Dart Aerospace Ltd.

Process Sheet

Drawing Name : WEBBING
Part Number : D3320041
Drawing Number : D3320 REV. A
Project Number : N/A
Drawing Revision : A
Material :
Due Date : 4/1/2008

DESIGN	REV	DART AEROSPACE LTD	
DRAWN	REV	HAWKESBURY, ONTARIO, CANADA	
CHECKED	REV	DRAWING NO. D3320	REV. D SHEET 2 OF 2
MFG. APPR.	REV	TITLE	SCALE
APPROVED	REV	WEBBING	NTS
DE APPR.	REV	COPYRIGHT © 2004 BY DART AEROSPACE LTD	
DATE	08.06.23	THIS DOCUMENT IS PRIVATE AND CONFIDENTIAL AND IS SUPPLIED ON THE EXPRESS CONDITION THAT IT IS NOT TO BE USED FOR ANY PURPOSES OR COPIED OR TRANSMITTED TO ANY OTHER PERSON WITHOUT WRITTEN PERMISSION FROM DART AEROSPACE LTD.

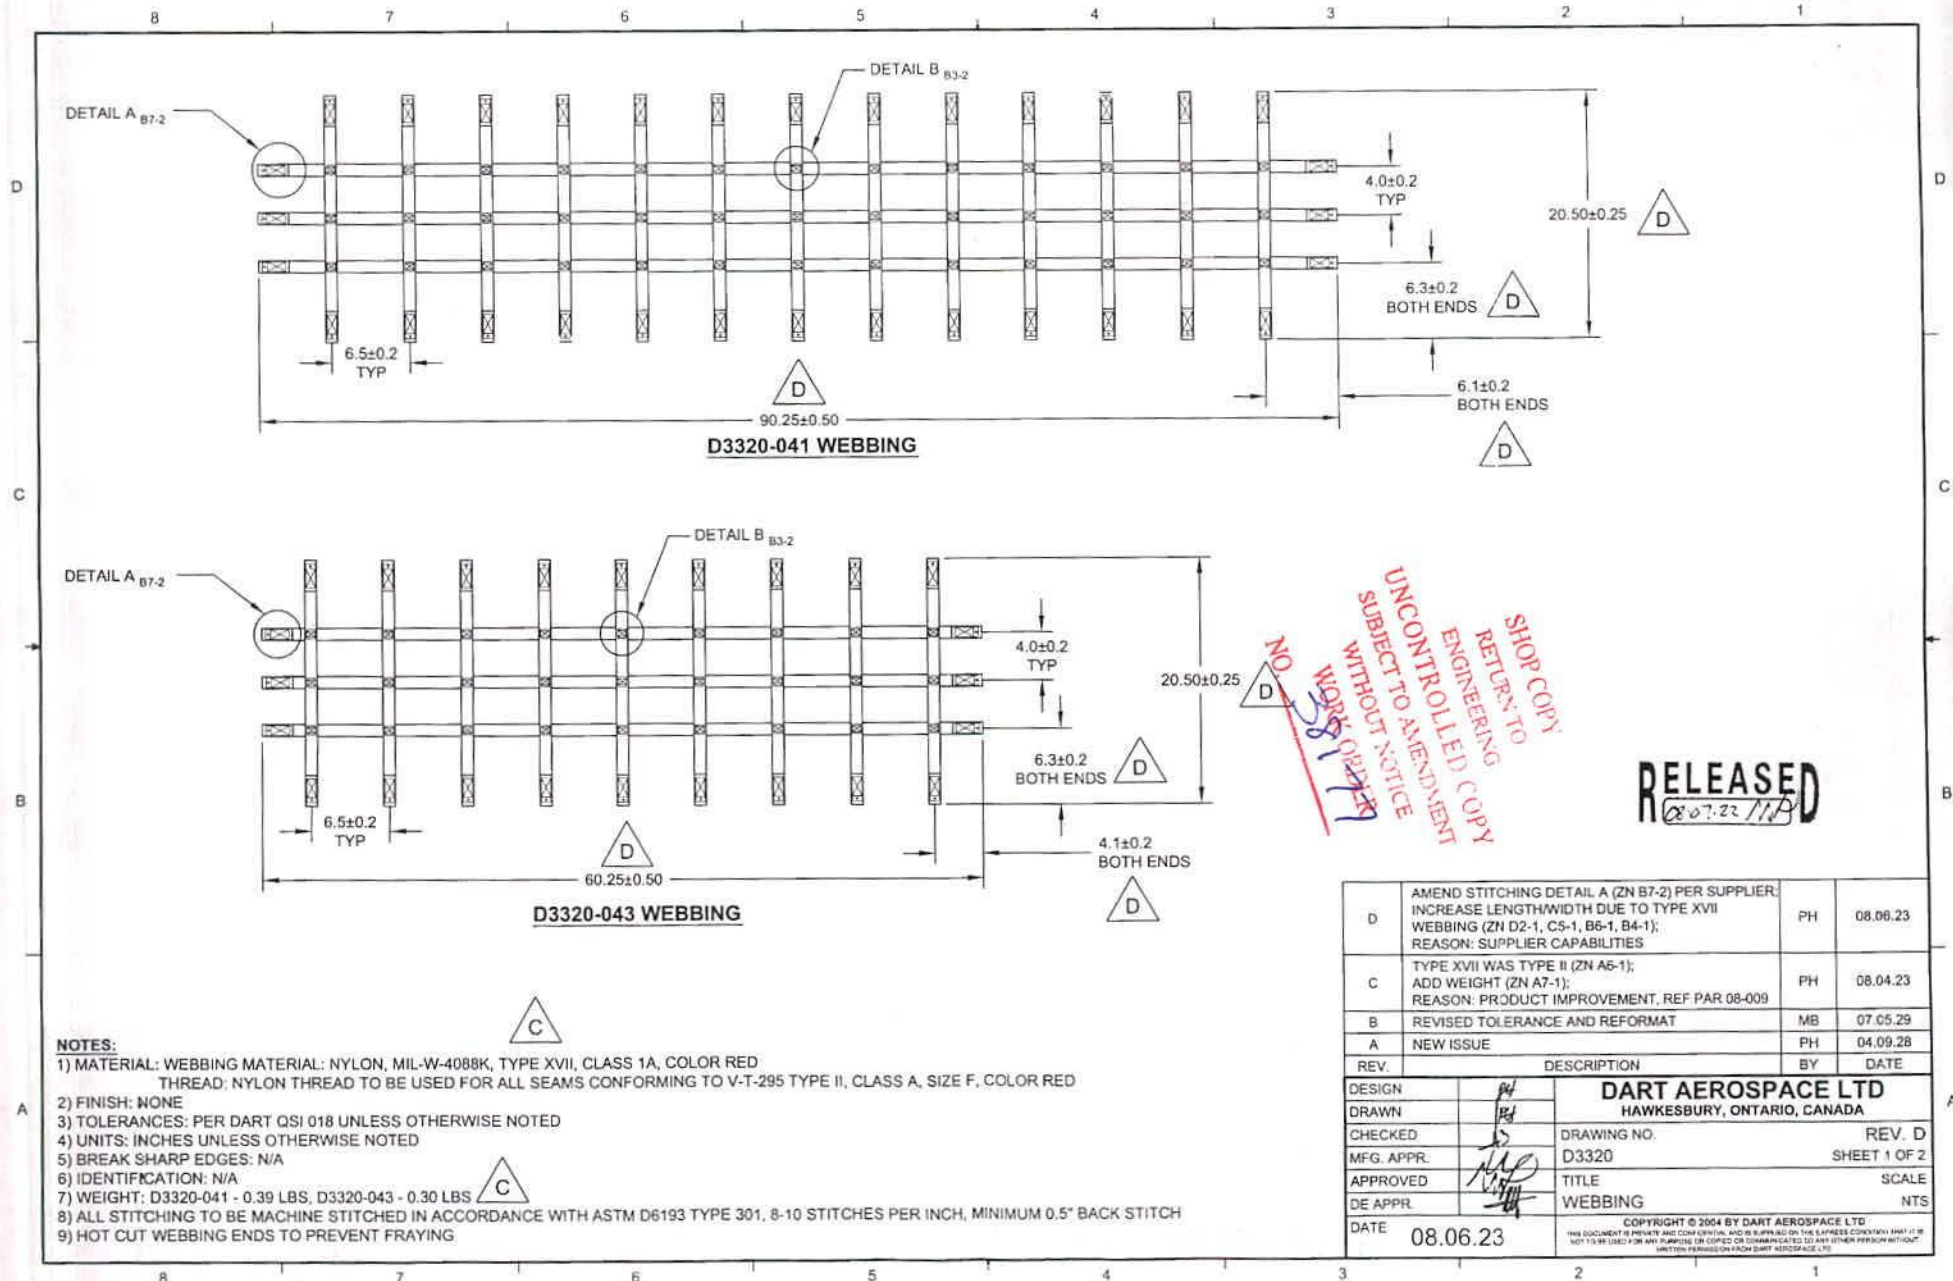
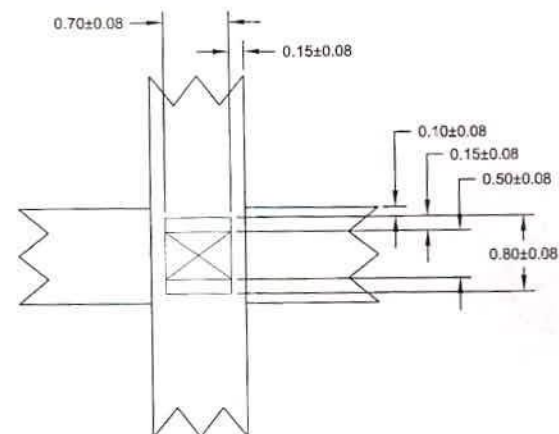
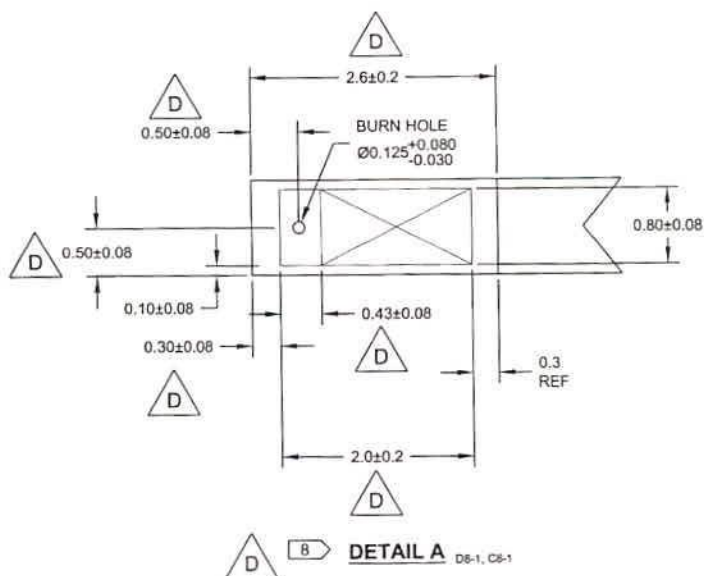
D	AMEND STITCHING DETAIL A (ZN B7-2) PER SUPPLIER; INCREASE LENGTH/WIDTH DUE TO TYPE XVII WEBBING (ZN D2-1, C5-1, B6-1, B4-1); REASON: SUPPLIER CAPABILITIES	PH	08.06.23
C	TYPE XVII WAS TYPE II (ZN A6-1); ADD WEIGHT (ZN A7-1); REASON: PRODUCT IMPROVEMENT, REF PAR 08-009	PH	08.04.23
B	REVISED TOLERANCE AND REFORMAT	MB	07.05.29
A	NEW ISSUE	PH	04.09.28
REV.	DESCRIPTION	BY	DATE
DESIGN	PH	DART AEROSPACE LTD HAWKESBURY, ONTARIO, CANADA	
DRAWN	PH		
CHECKED	PH		
MFG. APPR.	PH		
APPROVED	PH		
DE APPR.	PH	DRAWING NO. D3320 REV. D TITLE WEBBING SCALE NTS	
DATE	08.06.23	<small>COPYRIGHT © 2004 BY DART AEROSPACE LTD THIS DOCUMENT IS PRIVATE AND CONFIDENTIAL AND IS SUPPLIED ON THE EXPRESS CONDITION THAT IT IS NOT TO BE USED FOR ANY PURPOSE OR COPIED OR TRANSMITTED TO ANY OTHER PERSON WITHOUT WRITTEN PERMISSION FROM DART AEROSPACE LTD</small>
